AGENDA
REGULAR MEETING OF THE BIRMINGHAM PLANNING BOARD
WEDNESDAY MARCH 22 – 7:30 PM
151 MARTIN ST., CITY COMMISSION ROOM 205, BIRMINGHAM MI *

SUBJECT: 479 S. Old Woodward – Revised Final Site Plan & Design Review (no longer a Special Land Use Permit (SLUP) request)

BIRMINGHAM TOWERS MIXED USE

PROJECT + INFORMATION
BIRMINGHAM TOWERS
MIXED USE
479 S OLD WOODWARD AVE
BIRMINGHAM, MICHIGAN

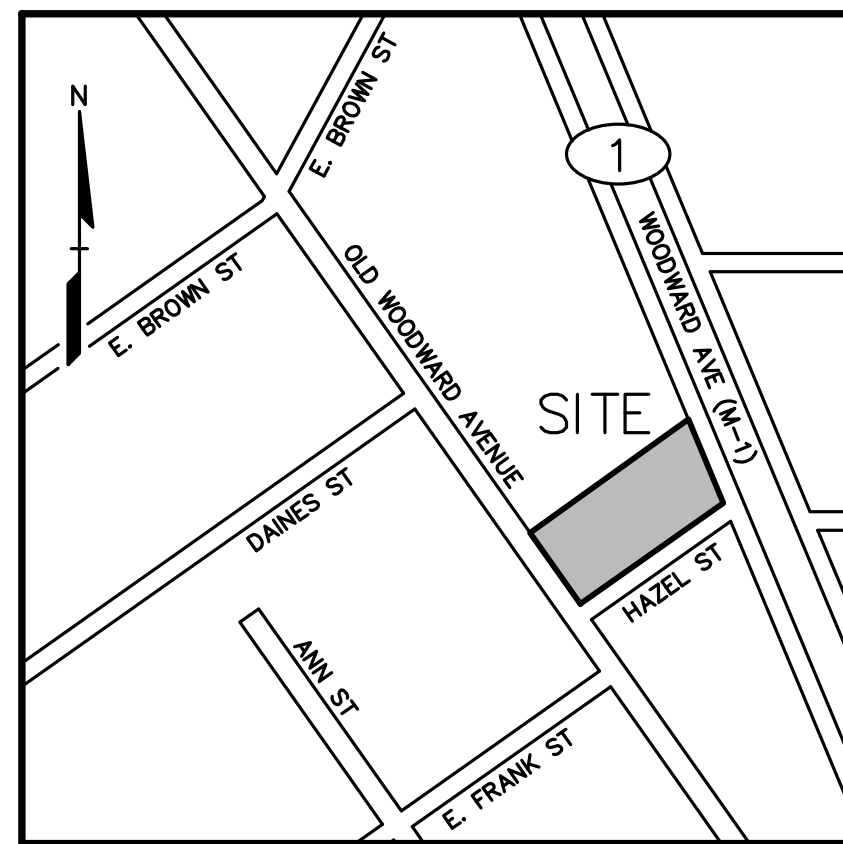
Article 4, Section 4.20(G) of Landscaping Standards requires 1 street tree for each 40 linear feet of frontage. The landscape plan submitted (sheet L-1.0) indicates two trees along S. Old Woodward, five trees along Hazel Street, and two trees along Woodward Ave as required by the Zoning Ordinance. The new trees along Hazel and Woodward Ave will be Jack Select Pear Trees 3" in caliber that will match what is existing on S. Old Woodward. **The applicant must provide updated streetscape plans to include city standard tree grates.**

The site plan approved in September of 2020 included six street lights along Hazel Street, however city standard street lights have not been included in the revised site plan. **The applicant must provide updated streetscape plans to include city standard street lights along Hazel Street.**

The Planning Division recommends that the applicant coordinate with City staff on providing the city standard tree grates, street lights, benches, and bike racks to ensure proper streetscape amenities are provided.

SP1.00

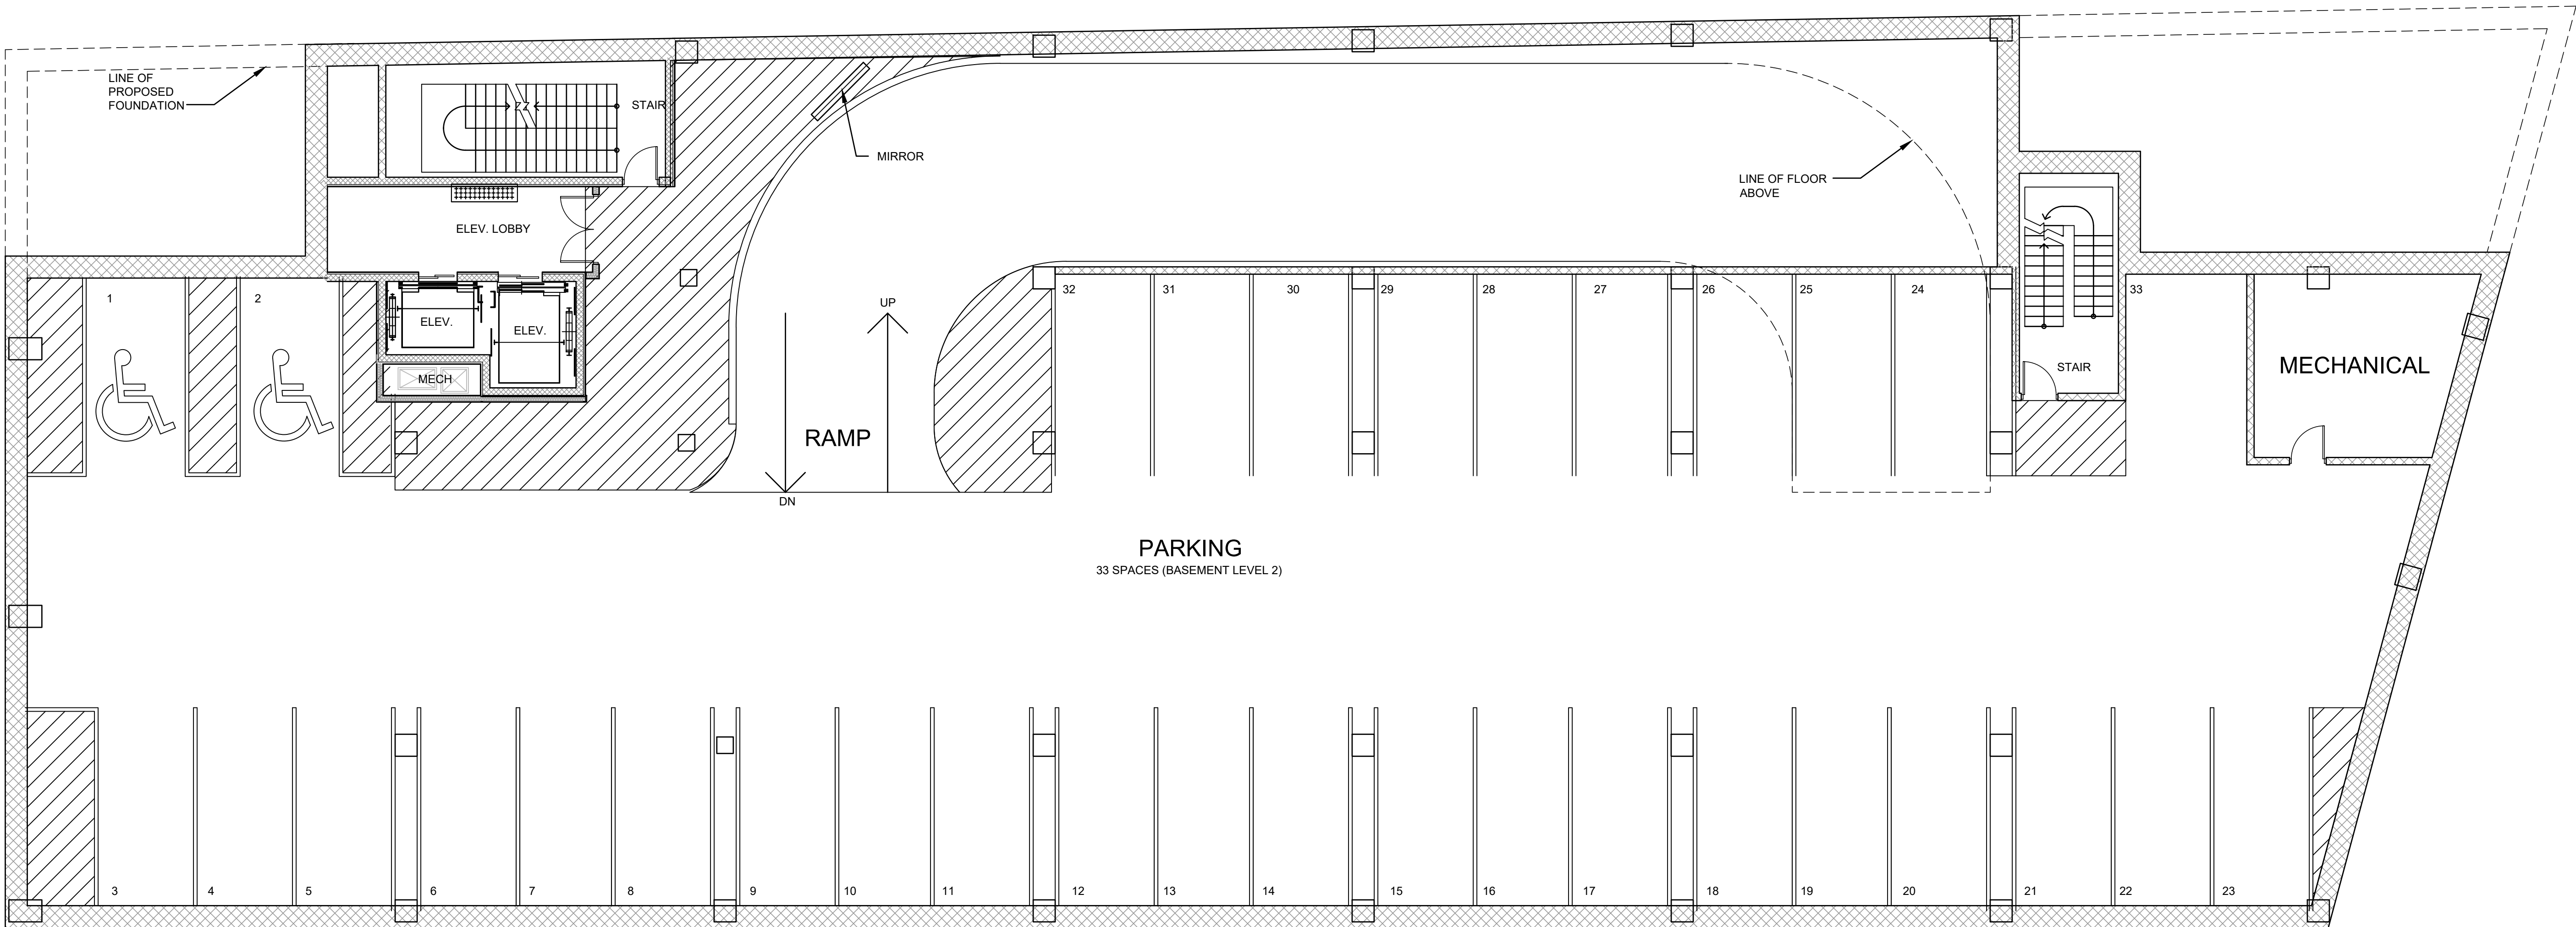
- 4.1 Parking – The applicant is once again proposing ground level parking and two levels of underground parking, similar to what was approved in 2020. An update is that the ground level parking spaces are now proposed with lift systems where two cars can be stacked in one space. The applicant is required to provide on-site parking for the first floor retail and restaurant uses, second and third floor office use, and 22 residential units on floors four and five.

The site plan indicates six parking spaces on the ground level within 20 feet of the building frontage of Hazel Street which does not satisfy the Zoning Ordinance. In January of 2021, the applicant obtained a dimensional variance of 20 feet for the proposed parking spaces along the Hazel Street frontage. Given that a substantial change to the site plan's location of ground level parking has not been made, the variance still stands.

The applicant is required to provide a total of 98 off-street parking spaces. The applicant is proposing 87 parking spaces on-site, therefore creating a shortage of 11 parking spaces. **The applicant must provide an additional 11 parking spaces on-site, or obtain a parking variance from the Board of Zoning Appeals.** The applicant has indicated that their preference is to pursue a variance for the remaining spaces with the Board of Zoning Appeals.

ROOF PLAN
SCALE: 1/8" = 1'-0"

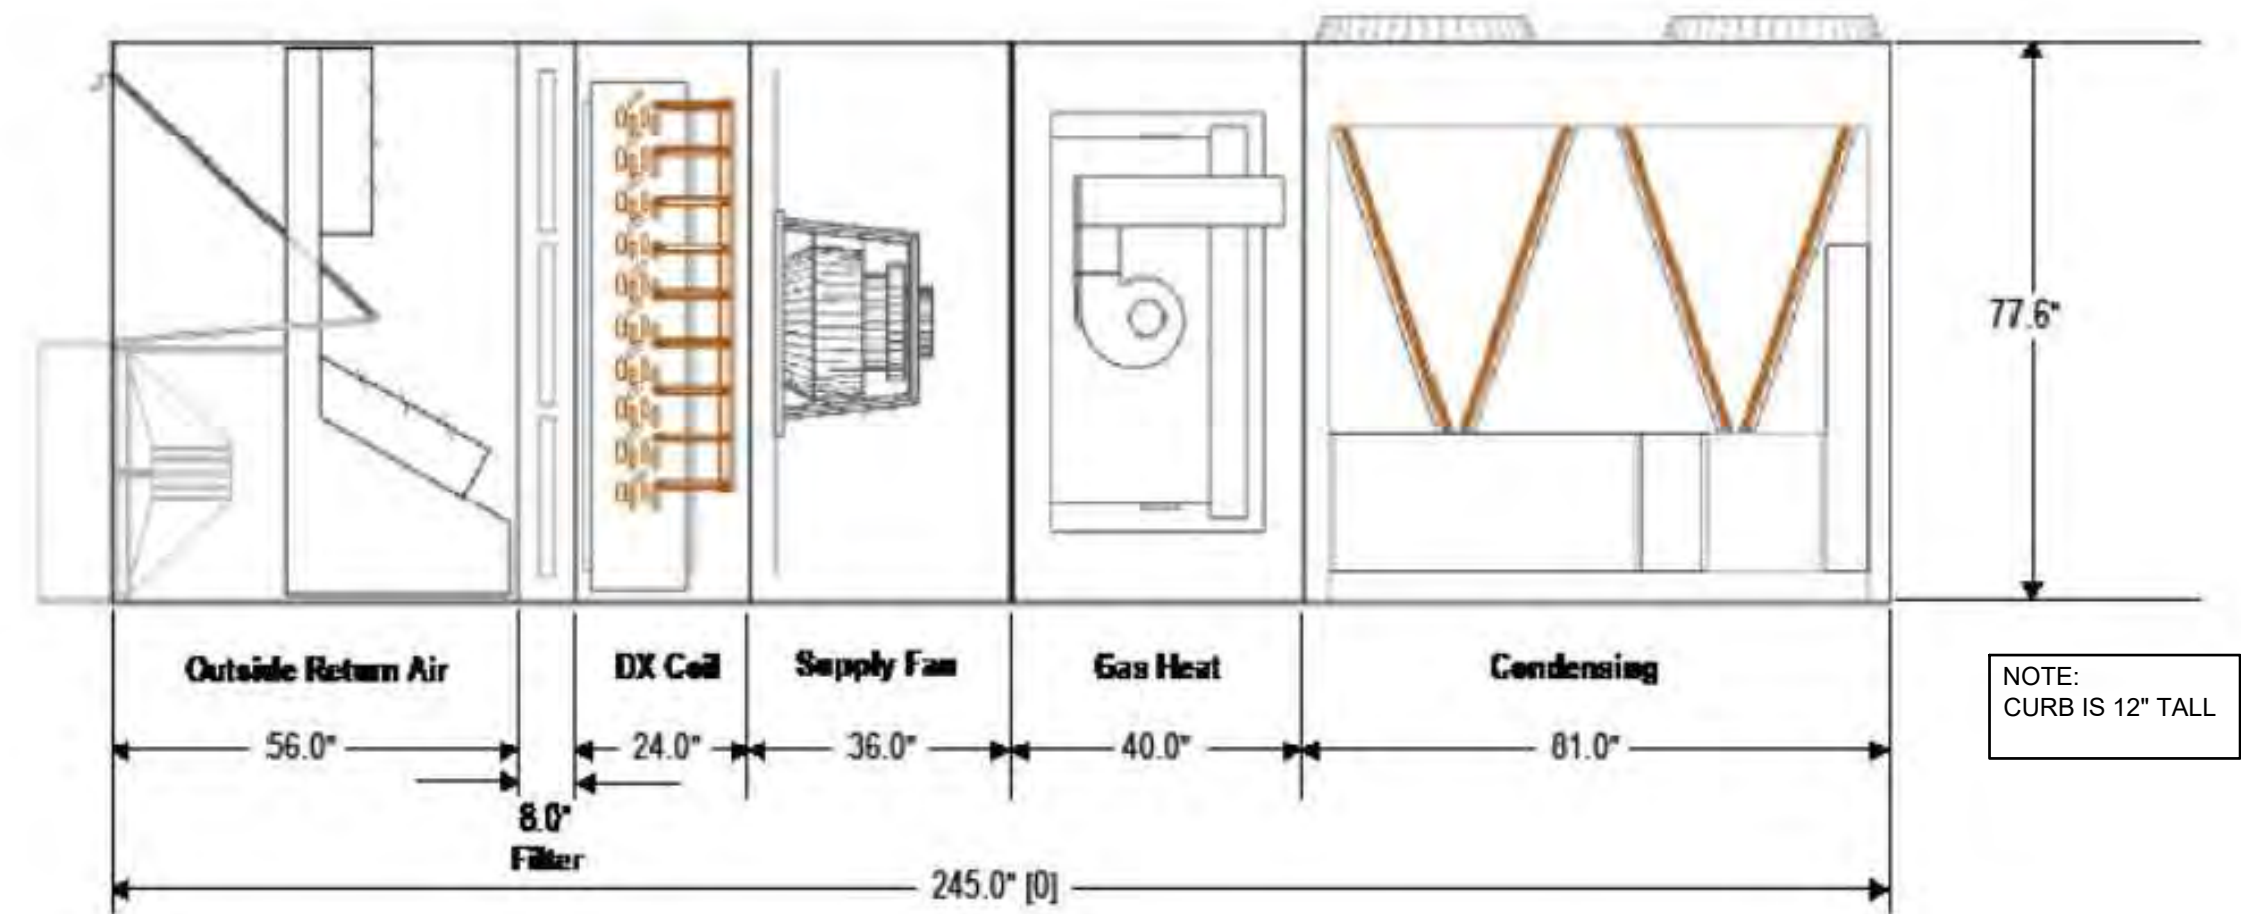
Additionally, rooftop structures and amenities may not contain habitable space. The applicant has submitted a rooftop plan showing a canopy that is fixed to the building. The shade structure for the rooftop use is set back over 11ft. from the eave line, meeting the requirements of the zoning ordinance.

WEST EXTERIOR ELEVATION

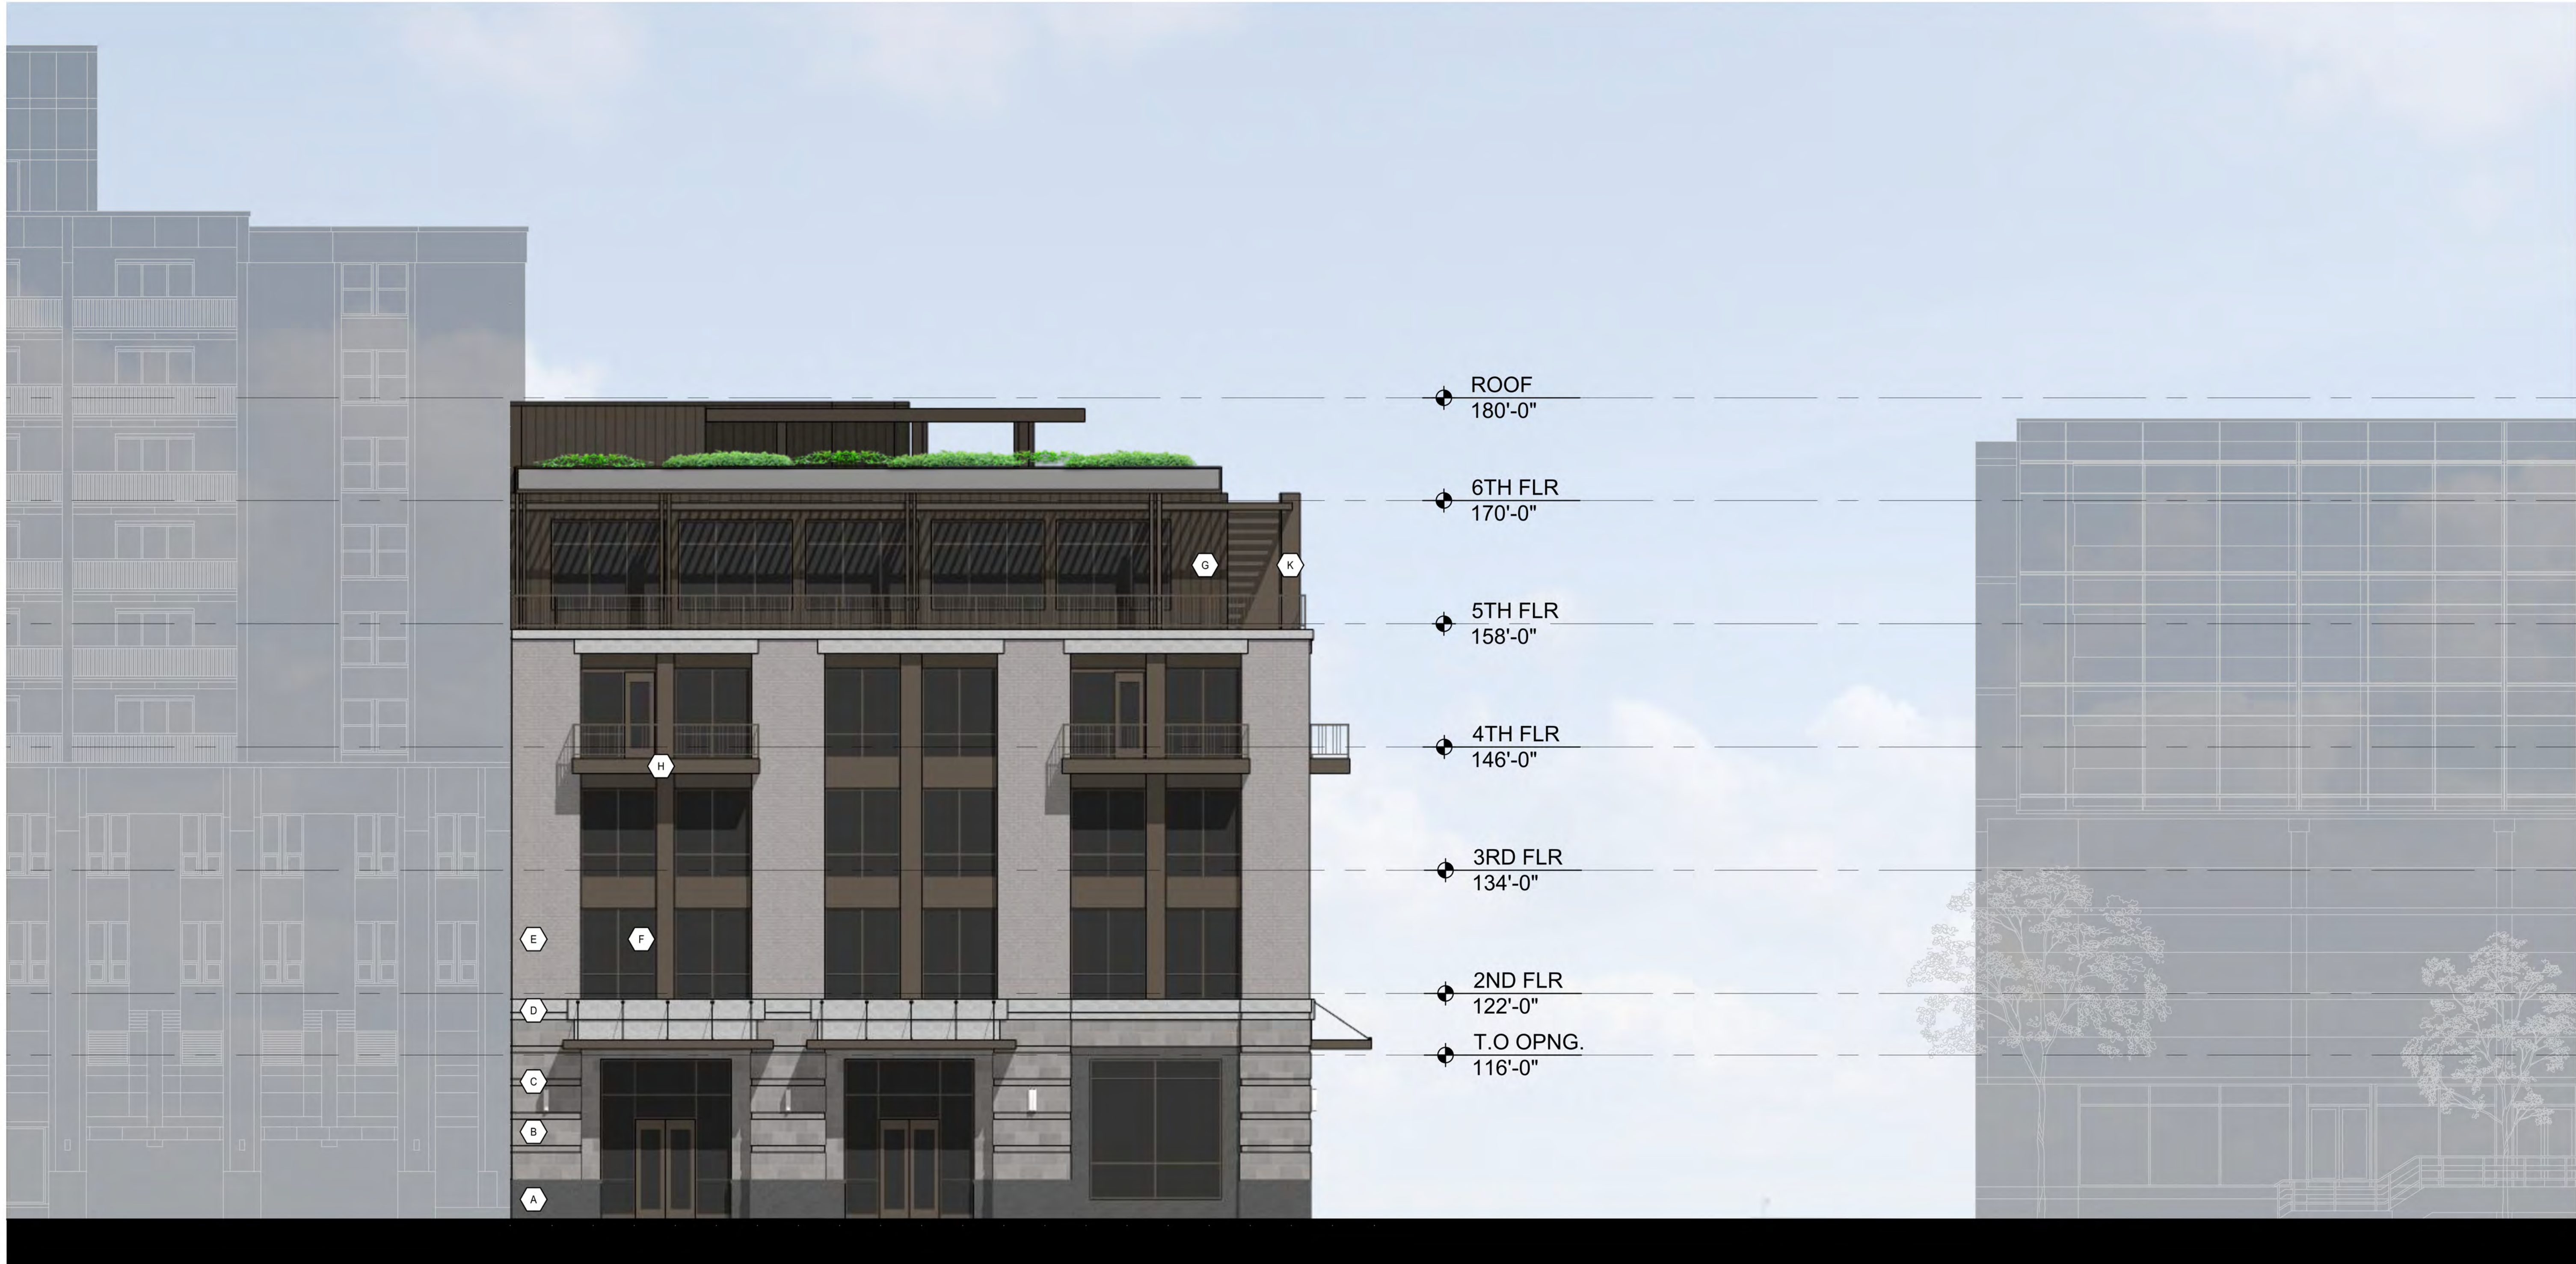
An empire gray colored brick veneer is proposed for floors two, three, and four. Another riesling colored cast stone band between the fourth floor and fifth floor is proposed. The fourth floor is proposed to have balconies consisting of dark bronze colored aluminum railing. Upper floor windows without balconies will have dark bronze panneling to match the window frames. The walls of the northern elevation for floors two, three, and floor will have blank walls consisting of empire gray brick. The Planning Board may wish to discuss requiring more architectural detailing here.

The applicant appears to meet the requirements of Article 3, Section 3.04 (E)(1) which requires at least 90% of the exterior finish material on all facades that face a street to be limited to the following: glass, brick, cut stone, cast stone, coarsely textured stucco, or wood. **The applicant must verify that the metal paneling does not exceed 10% of the buildings finish material.**
